POR
CT-1487

SUBJECT: REVIEW OF GE DECAY HEAT PROPOSAL

A Review of GESSAR II, Appendix 6A
"Improved Decay Heat Correlation for LOCA Analysis"

FIGURE 1

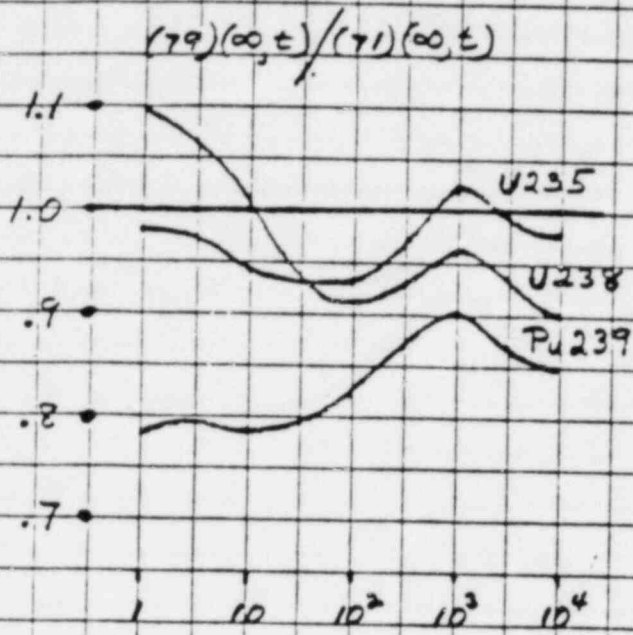
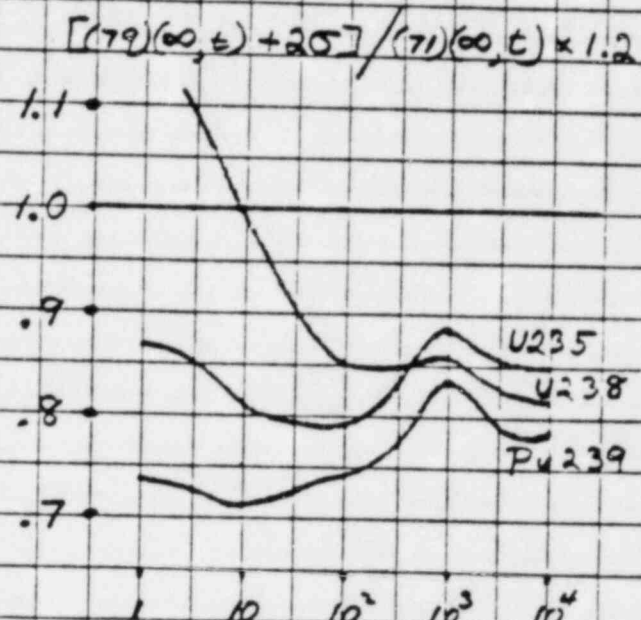
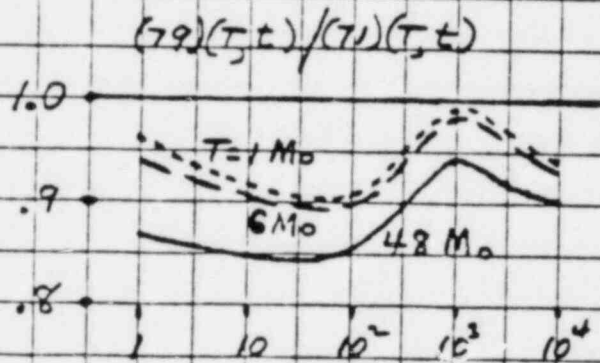
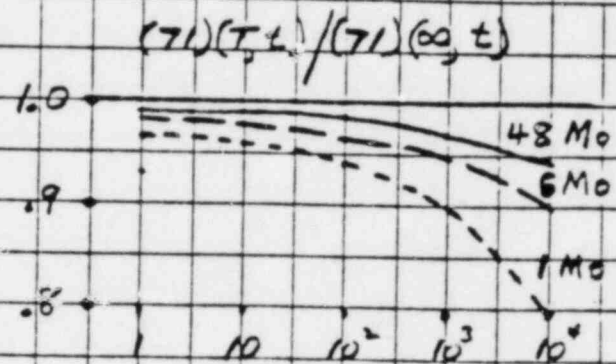
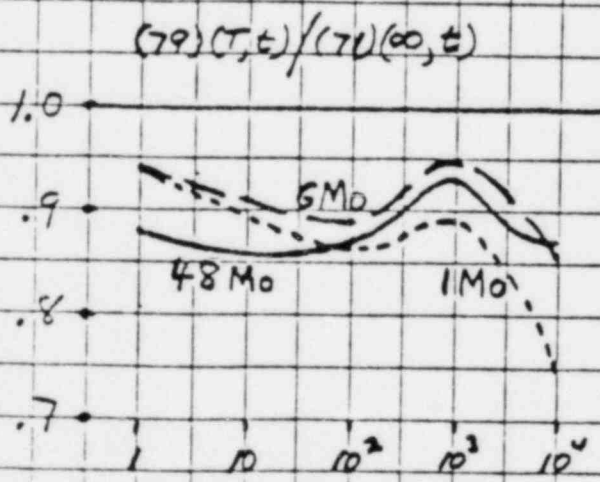
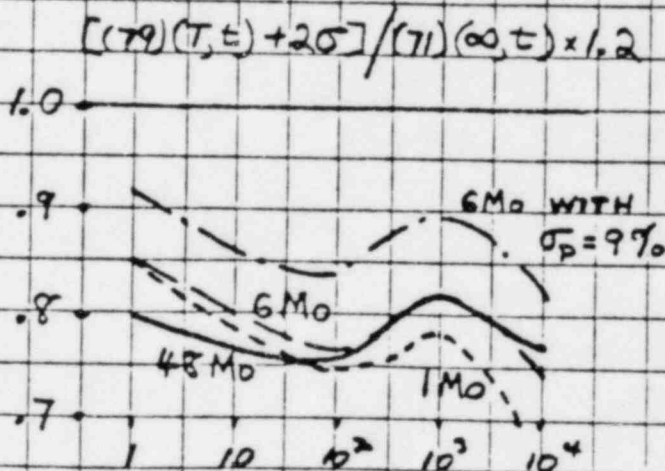
An indication of the quantitative nature of some of the elements of potential changes are given in Figure 1, Page 6:

- 1a. compares new isotopes best estimates to old U235. There is as much as a 6 percent decrease in U235 in part of the LOCA range, but less or even an increase in other parts. There is a much larger decrease from Pu239, ranging from 10 to 20 percent.

1b. makes the same comparison with a 2σ uncertainty included and comparing these values to $1.2 (71)(\infty, t)$. A large decrease of about 15 to 30 percent is provided by U235 and Pu239.

1c. provides a comparison (of nominal values) with the combined isotopic effects for reactor operation with burnup assuming operation at constant power for the indicated times (1 to 48 months). Isotopic changes with burnup approximately correspond to a BWR-3 fuel assembly. The comparison is for isotopic effects only since the same finite time T is used for both (71) and (79). The indication is that new FPDH data provide decreases of about 5 to 15 percent.

1d. indicates the decreases provided by just the use of finite operating time rather than infinite. The trend is somewhat complementary to that in 1c. The reductions are of the order of 1 to 10 percent.

1e. combines the effects of 1c. and 1d. to give a best estimate comparison between (71) and (79) for a BWR-3 assembly. The result is about a 10 percent decrease. (Also note that larger T values do not always produce larger FPDH.)

1f. makes the comparison using 2σ augmented values for (79) vs. Appendix K. The result is about a 20 to 25 percent decrease in FPDH as a bottom line for the comparison. (The curve with $\sigma_p = 9\%$ will be discussed later.)

Note that figure 1f includes a (six month) curve with a $\sigma_p = 9\%$ ($2\sigma = 18\%$) power density uncertainty (σ_p) statistically combined with FPDH uncertainty. The reduction gained by use of (79) is reduced significantly.
